**TEMPERATURE FLUCTUATION**

**DESCRIPTION:**

**TAB A:**

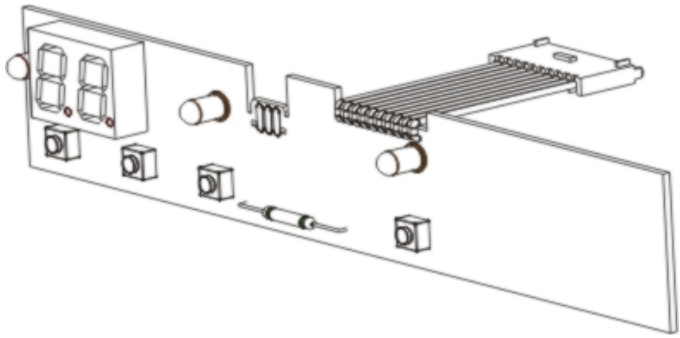
In relation to the equipment listed in Table A, (385 Cooler Dy) excluding those with the ERF2001 circuit board, temperature fluctuation and warm refrigerator phenomena can occur.

To resolve the problem, the temperature setting on the board has been reduced by 1.5°C. To do this for equipment that is already on the market, it is necessary to replace the circuit board as reported in the table below.
